PARADIS, Willy

On August 12, 1980 I recieved a call from Richard Paradis concerning a soil evaluation. He informed me that he had built a workshop on his fathers land (Willie Paradis) and also wanted to build a two bedroom home, attached. When he went for a building permit he was informed that he needed a Soil test, first. Unknowingly he had already constructed a leach field for the shop/home combination before any soil testing was done. With this in mind, I went to the site and examined the soil and lot and recieved the information about the leach field design you will find on the attached HHE-200 form.

MAINE DEPARTMENT OF HUMAN SERVICES
APPLICATION FOR PRIVATE SEWAGE DISPOSAL PERMIT

Site Plan

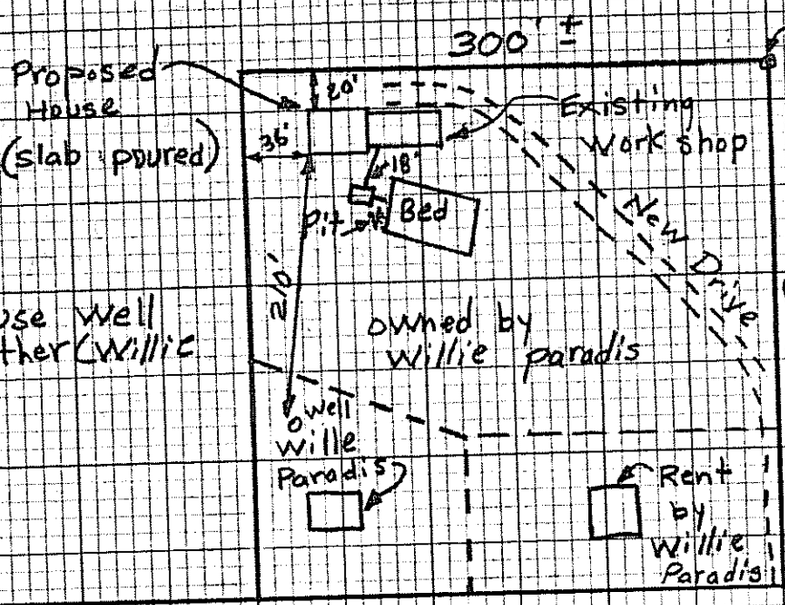
Proposes to use well owned by father (Willie Paradis).

Private Sewage Disposal Plan

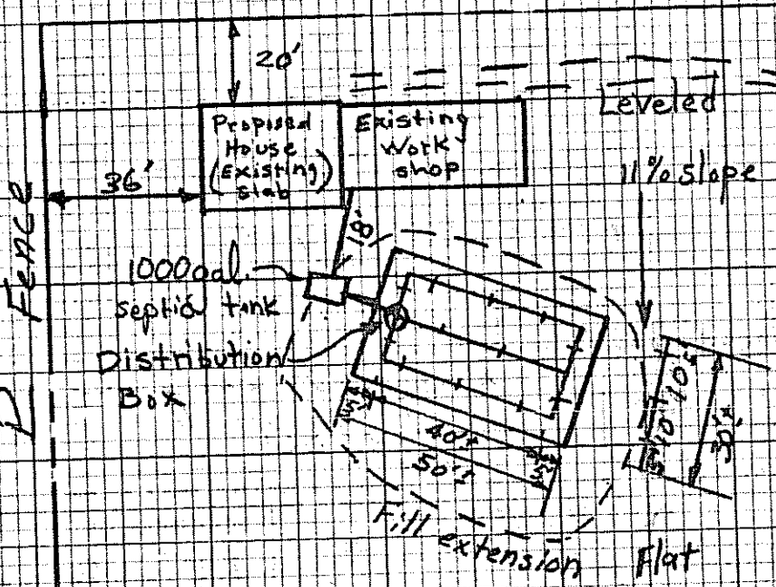
Bed layout as told by Richard Paradis. (approximate)

Possibly fill extension, down hi should be lengthened.

Subsurface Absorption Area Cross-Section

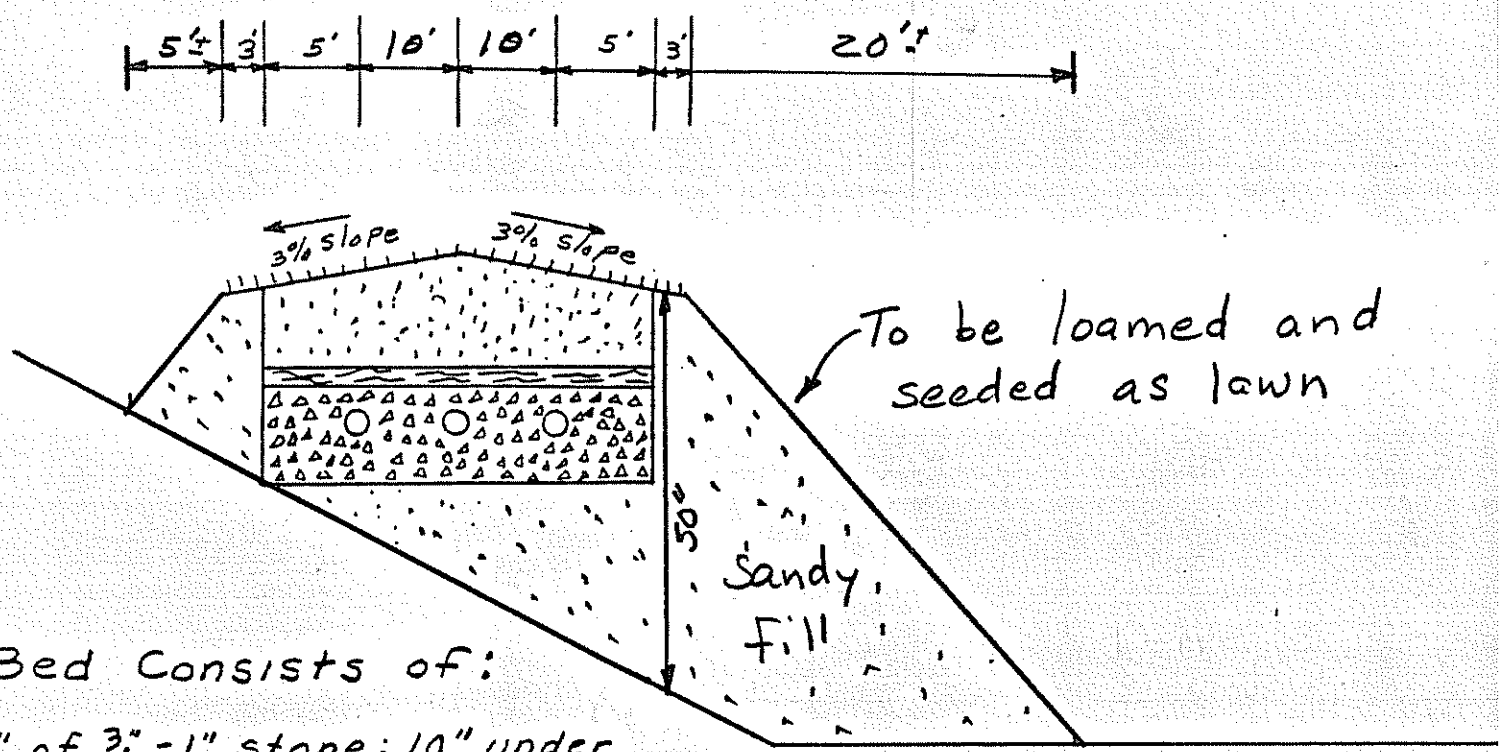
Approximate design as told to me by Dick Paradis.

I did not establish a bench Mark because the bed was already installed and I could not see the need for one.
